REQUEST FOR INFORMATION NOT ADDRESSED IN THIS CCO REMAIN IN FORCE				
MARK	DATE	DESCRIPTIONS	BY	CH'D CCO#
3	02/17/12	CABLE TRAY COVER AT W2	RSB RG	234
2	03/01/11	BASE INTEGRATION	RSB WB	150
1	11/20/09	ELECTRICAL GROUNDING	RR AW RG FW	75
0	02/25/08	CABLE TRAY CHANGES	TW RG SE	4251

CONTRACT CHANGE ORDER NO. **234**
 SHEET **2** OF **7**

FOR REVISION ONLY
DETAILS UNDERGROUND PIER W2W PLANS AND SECTIONS
 SCALE AS NOTED

E-20B

E-213

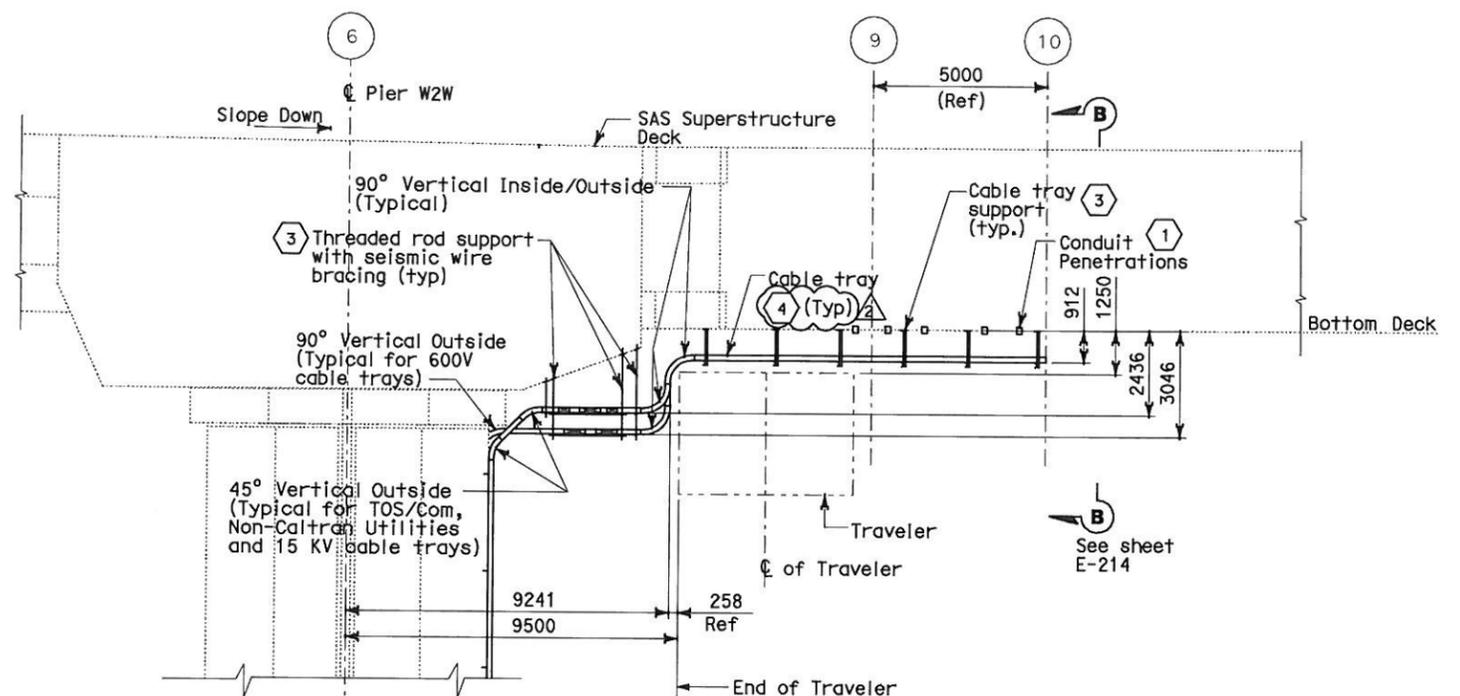
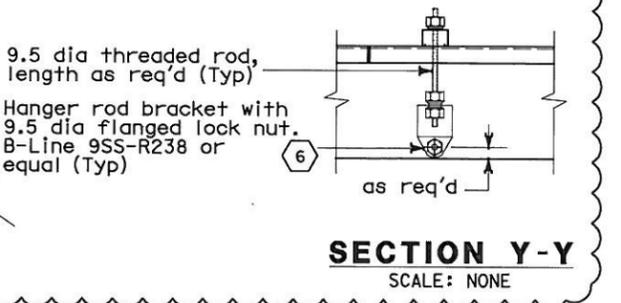
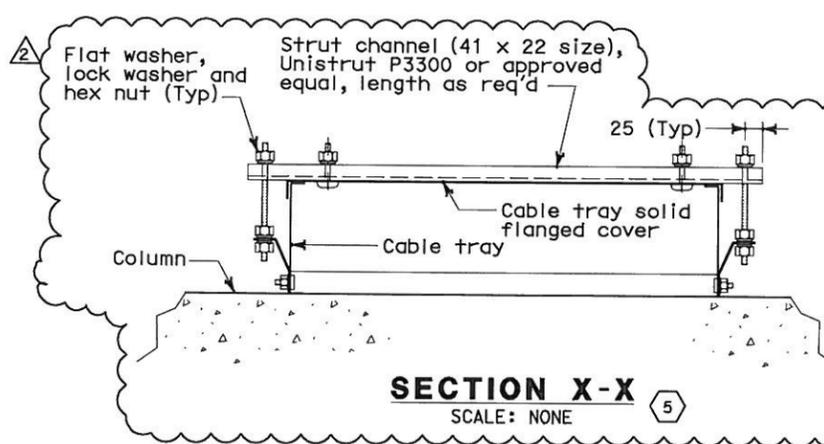
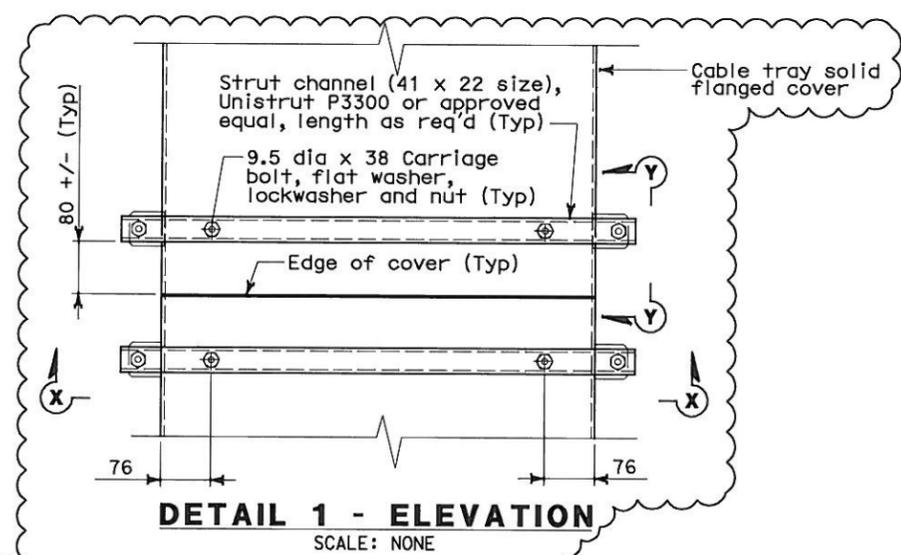
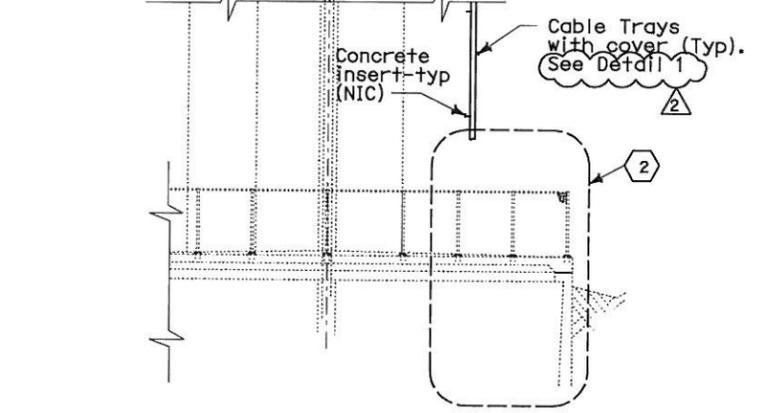
MARK	DATE	DESCRIPTIONS	BY	CH'D	CCO#
②	02/17/12	CABLE TRAY COVER AT W2	RSB	RG	234
①	02/25/08	CABLE TRAY CHANGES	RG	SE	4251

- SHEET NOTES:**
- ① See sheet E-212 for location.
 - ② For Pier W2E details, see sheet E-21, E-21E and E-21F.
 - ③ For cable tray support type and location, see sheet E-212.
 - ④ All cable tray under the girder shall have peaked flanged cover on top and solid flanged cover at the bottom with approved heavy duty cover clamps. Vertical cable tray run on the column shall have solid flanged cover on top and no cover at the bottom except where cable tray is not flush with the columns.
 - ⑤ All hardware shall be 316 stainless steel.
 - ⑥ Contractor shall install the hanger rod bracket clear from the existing cable tray supports and concrete inserts.
